Application for change or cancellation of resource consent condition (S.127)

Change of conditions (s.127)

Shift the boundaries of Lot 6 - 8, create a right of way ('I and 'J') for Lots 6 - 8, shift the indicative building platforms for Lots 6-9, amend the location of the drainage easements, change Lot 15 from a road to vest to a common access lot, and various other changes listed in the main report.

5. Reyburn and Bryant has prepared an amended scheme plan (S17346, Revision B). A copy of it is **enclosed**.

Proposed scheme plan prepared by Reyburn and Bryant (S17346, Revision B)

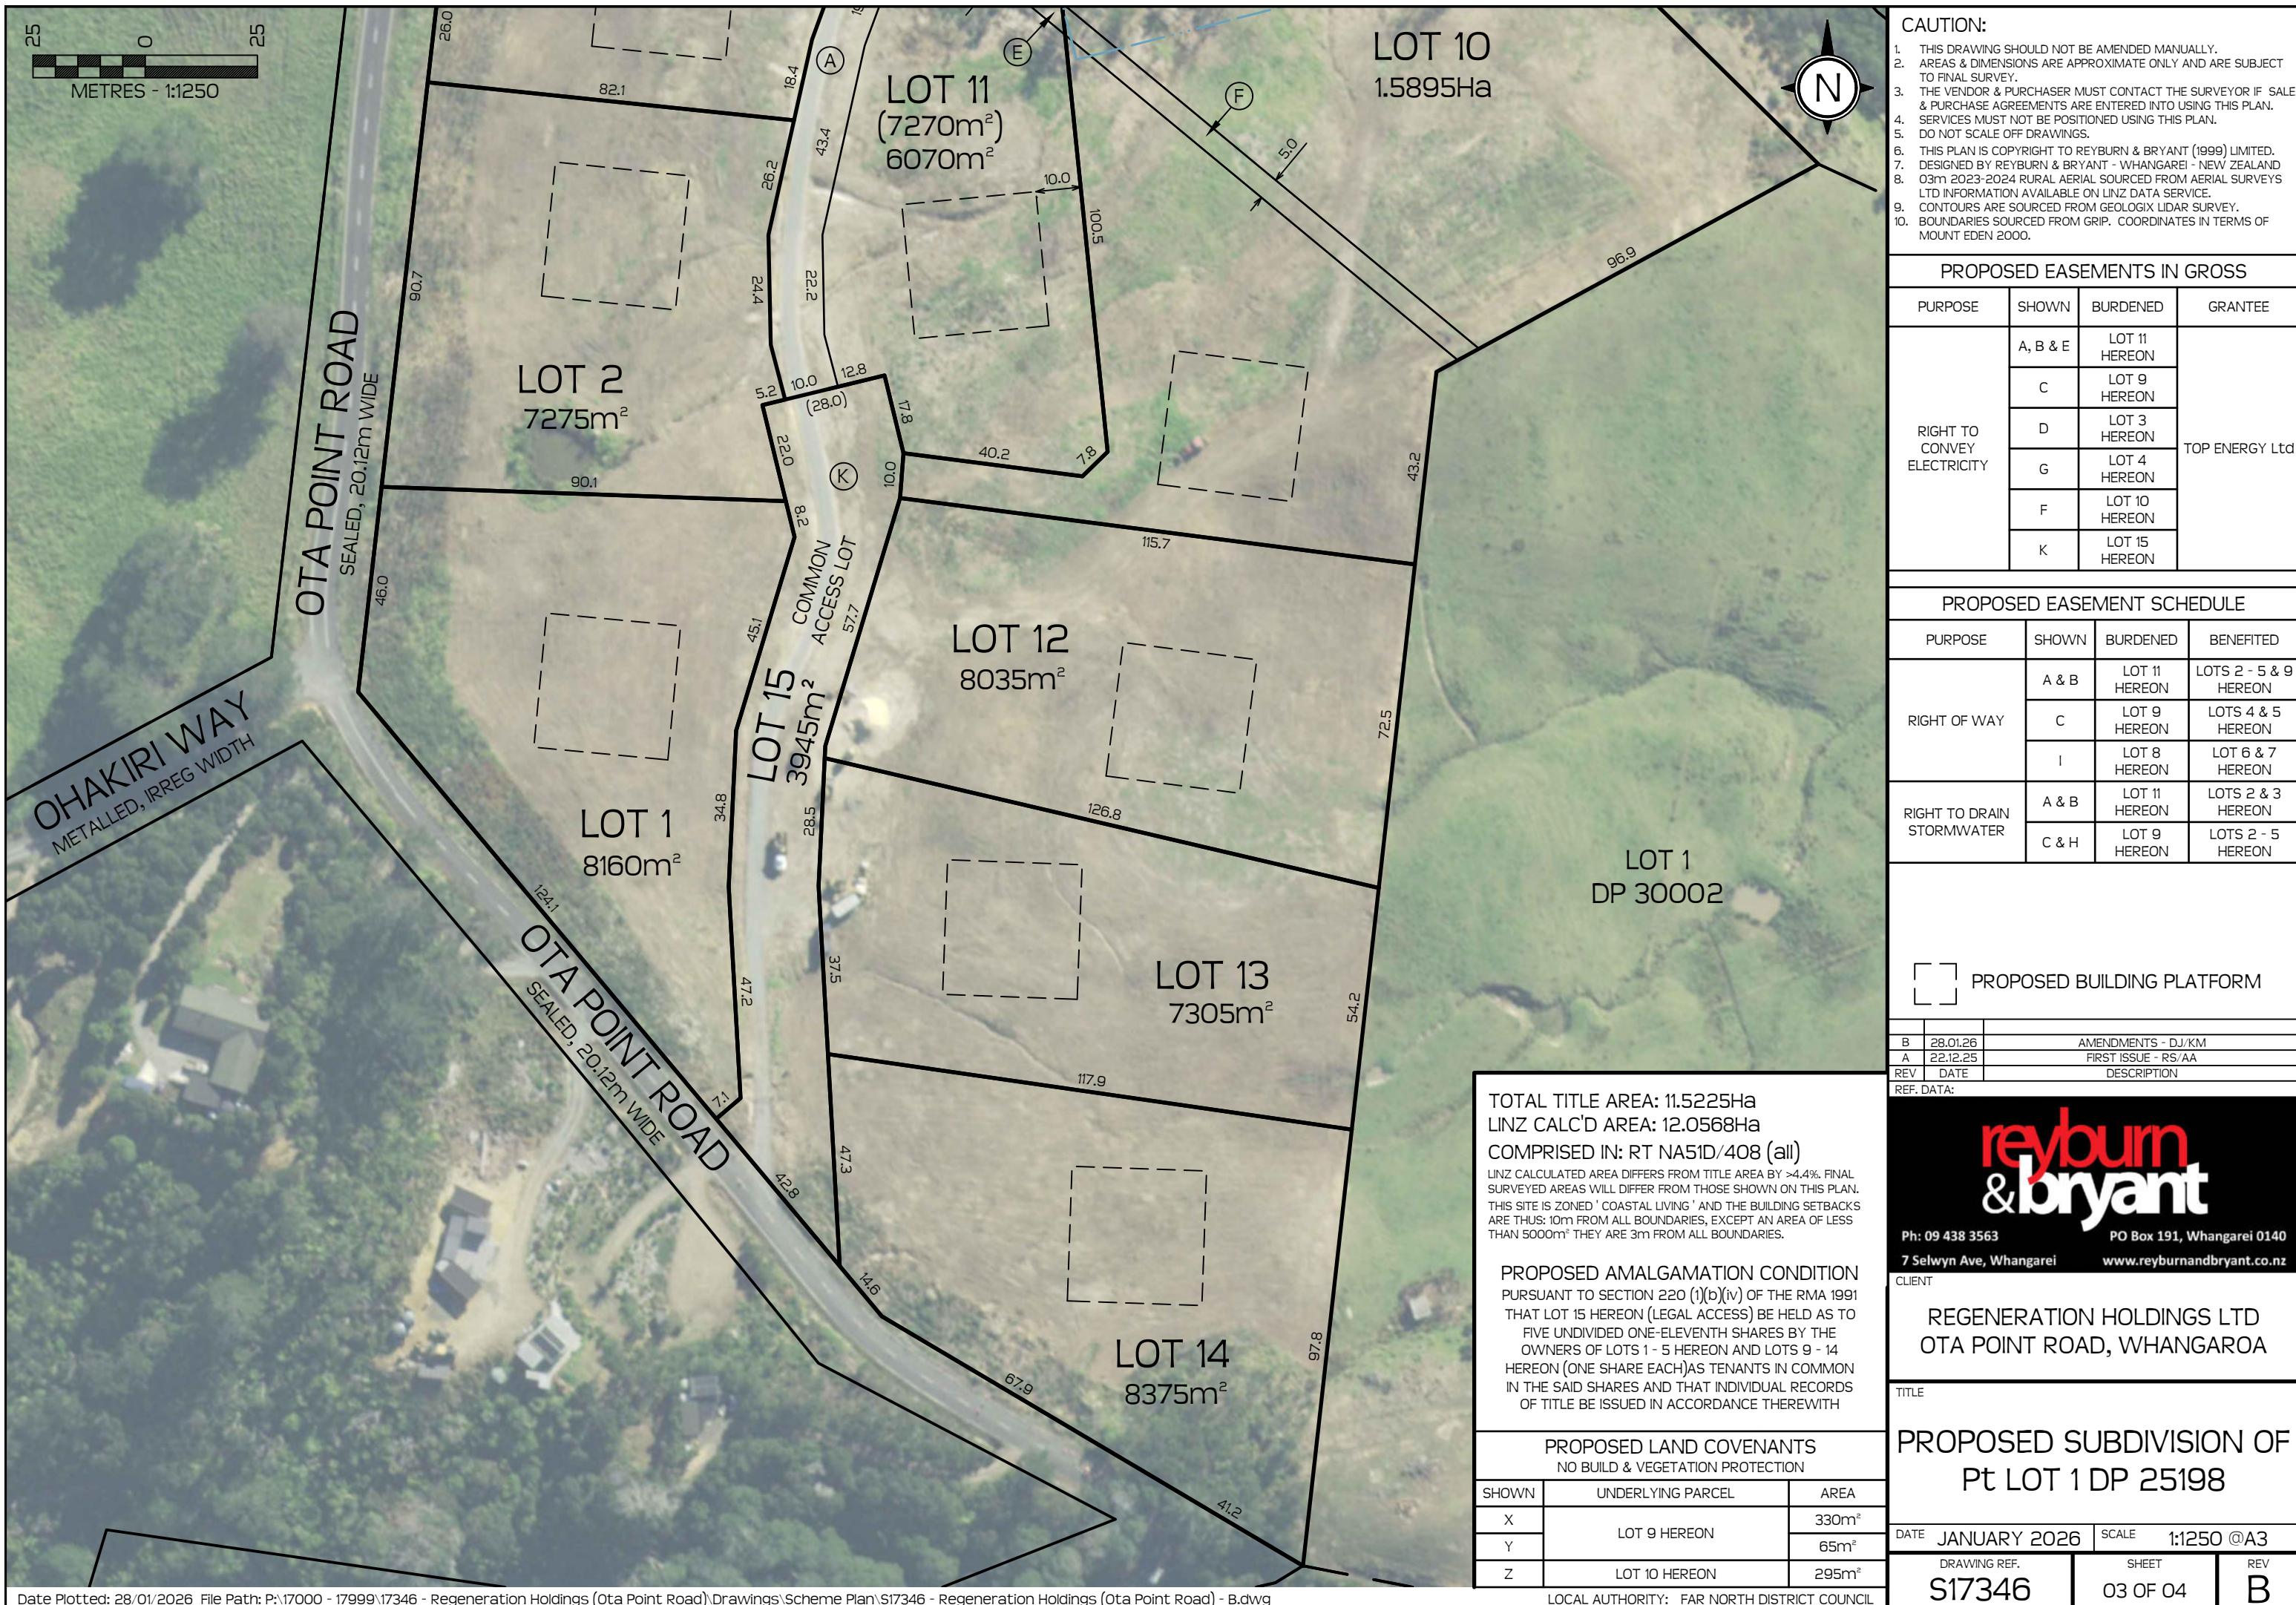
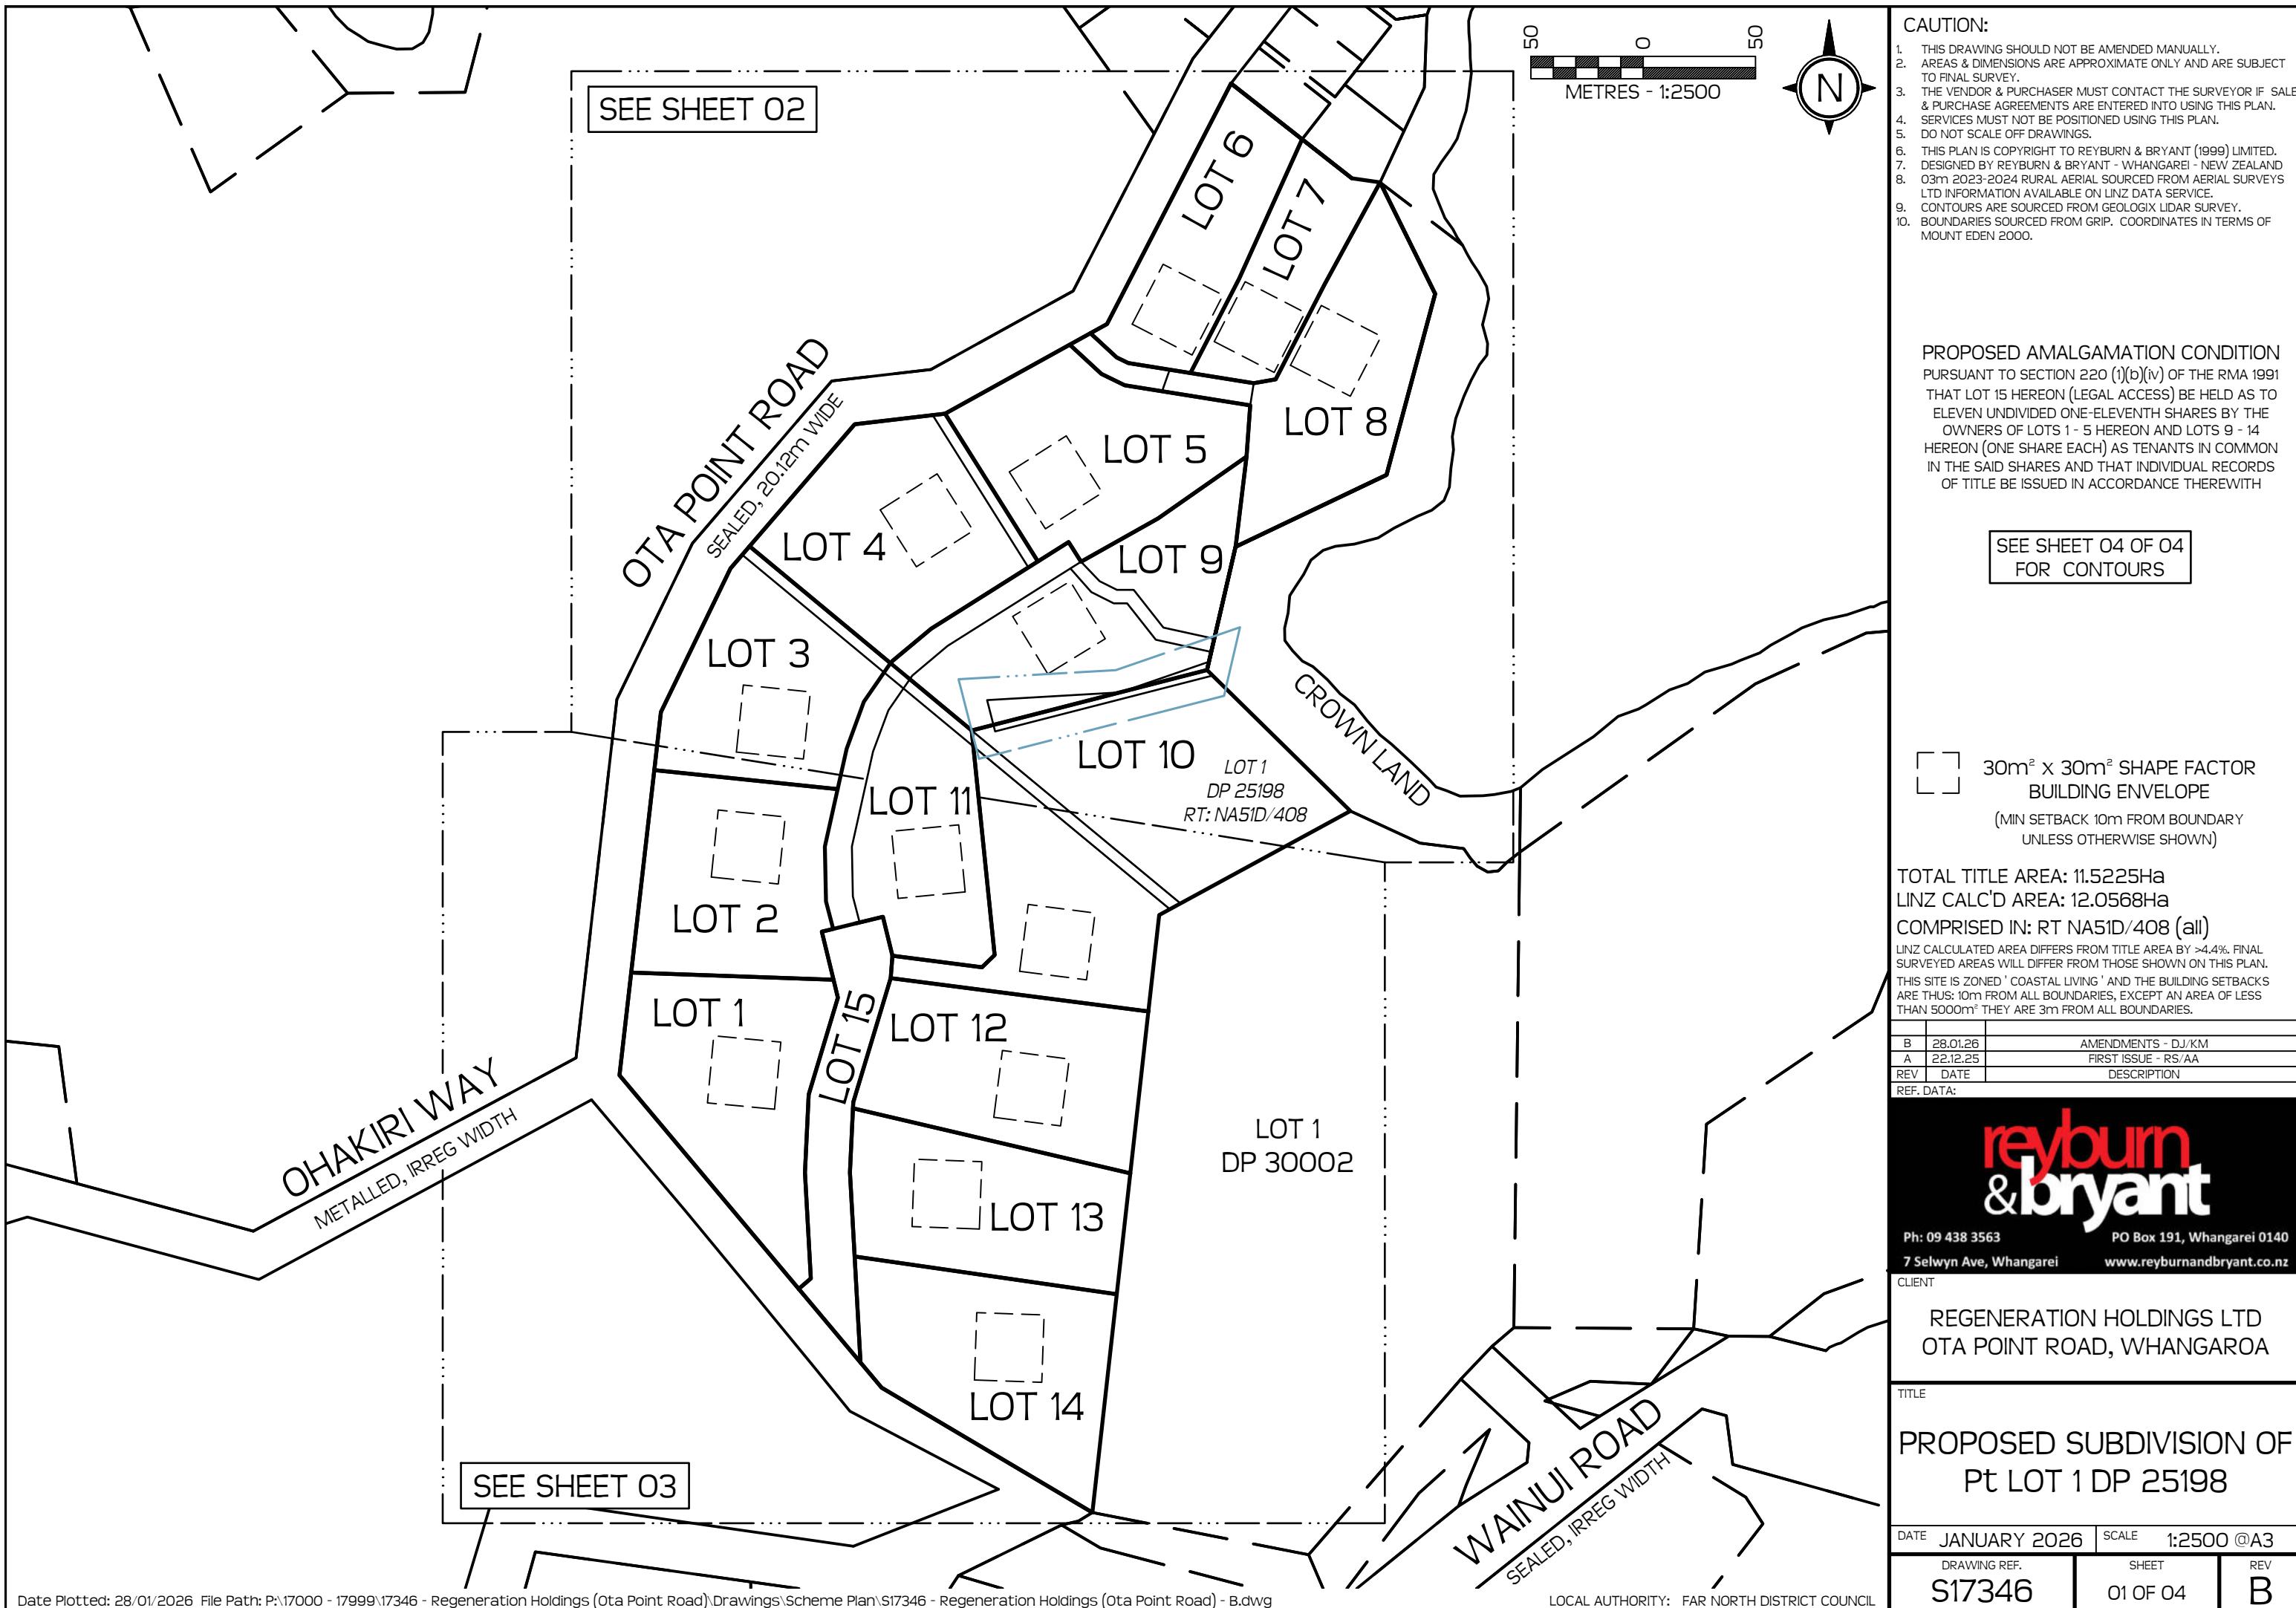
9. The shifted boundaries of Lots 6 – 8 facilitate new indicative building platforms. These are either in approximately the same location as the building platforms shown on the approved scheme plan (Lots 6 and 8) or will be further away from adjacent properties and encompassed by other indicative building platforms (Lot 5). The amended lot sizes³ remain in general accordance with the approved scheme plan as they differ by less than 10% from what was approved.⁴

12. Minor changes have been made to the boundaries and sizes of the other lots. Regardless, the lots are generally in the same location as the approved scheme plan, and the sizes remain in general accordance with what was originally approved.

15. It is proposed to change Lot 15 from a road to vest to a common access lot to reduce the formation standard and reduce the extent of earthworks required. Nonetheless, the new formation will still be appropriate for the eleven users.
